LIMERICK GENERATING STATION
Units 1 and 2

PROPOSED OPERATING LICENSE CHANGES
No. 93-24-0

These pages reflect proposed changes due to APRM Rod Block Monitor
Technical Specifications/Maximum Extended Load Line Limit Analysis
(ARTS/MELLLA) implementation submitted to the NRC by letter dated August
27, 1993 prior to Power Rerate.

Figure 3.4.1.1-1 THERMAL POWER VERSUS CORE FLOW

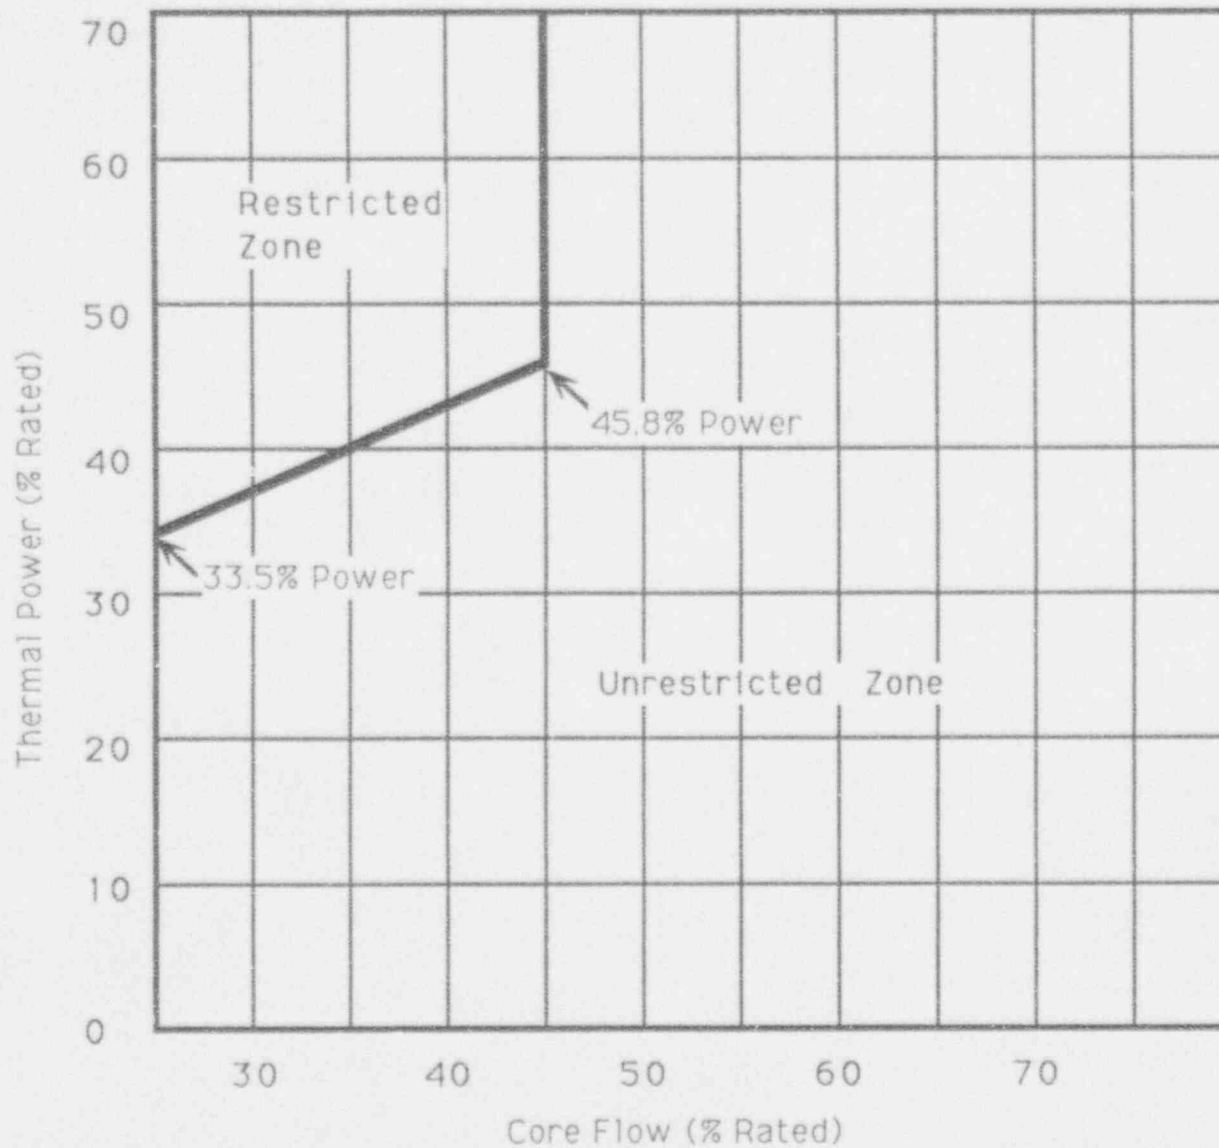
- a. Total core flow greater than or equal to 45% of rated core flow, or
- b. THERMAL POWER within the unrestricted zone of Figure 3.4.1.1-1.

- a. Reactor THERMAL POWER is \leq 76.2% of RATED THERMAL POWER,
- b. The recirculation flow control system is in the Local Manual mode, and
- c. The speed of the operating recirculation pump is \leq 90% of rated pump speed.
- d. Core flow is greater than 39% when THERMAL POWER is within the restricted zone of Figure 3.4.1.1-1.

Figure 3.4.1.1-1 THERMAL POWER VERSUS CORE FLOW

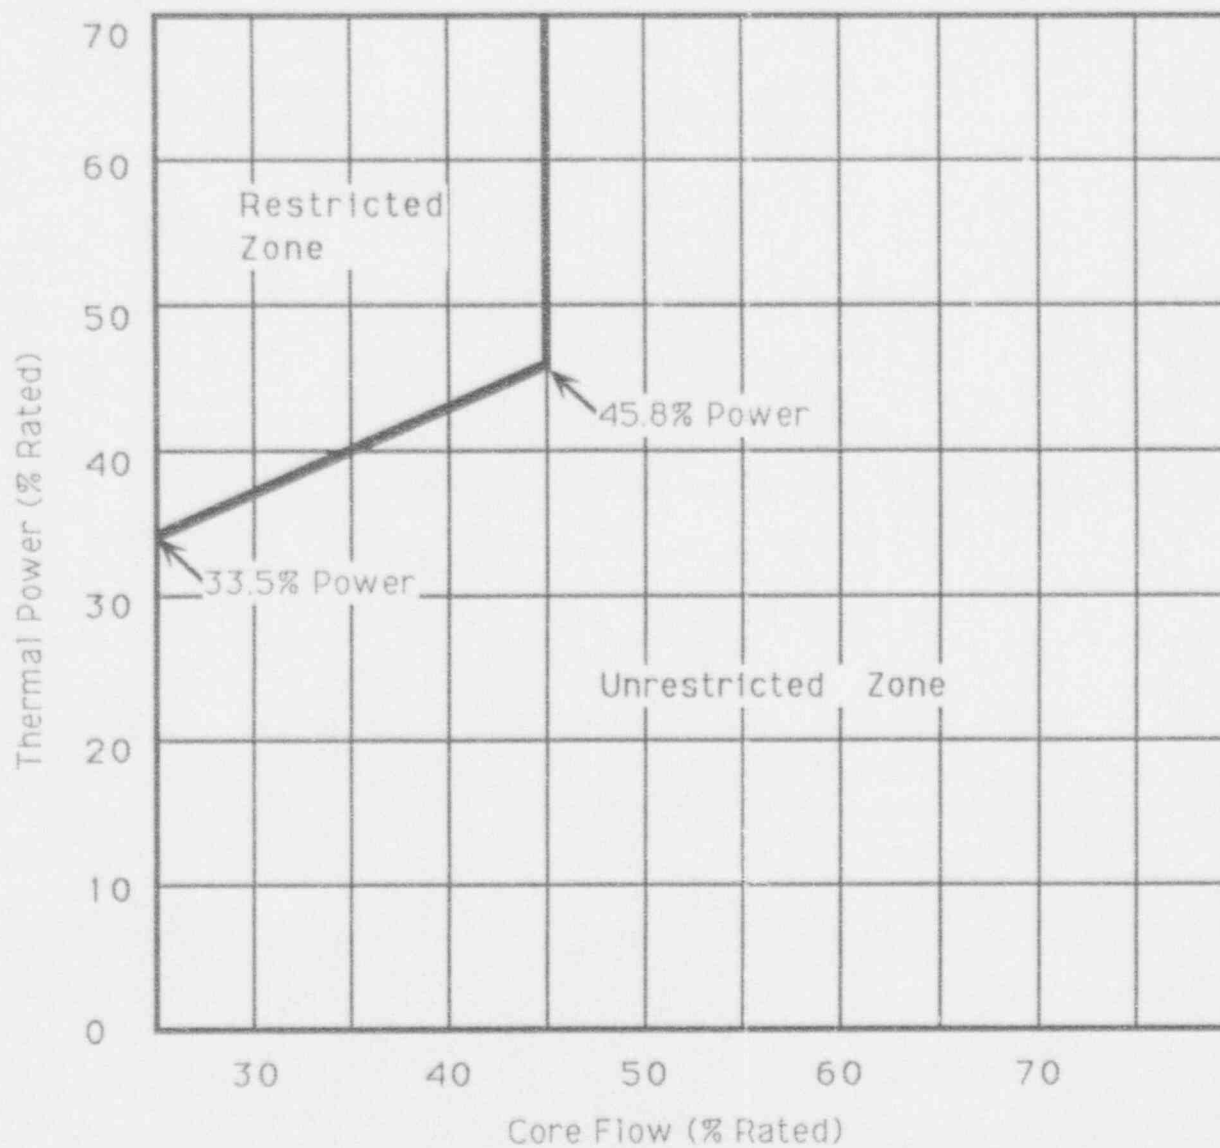
- a. Total core flow greater than or equal to 45% of rated core flow, or
- b. THERMAL POWER within the unrestricted zone of Figure 3.4.1.1-1.

- a. Reactor THERMAL POWER is \leq 76.2% of RATED THERMAL POWER,
- b. The recirculation flow control system is in the Local Manual mode, and
- c. The speed of the operating recirculation pump is \leq 90% of rated pump speed.
- d. Core flow is greater than 39% when THERMAL POWER is within the restricted zone of Figure 3.4.1.1-1.
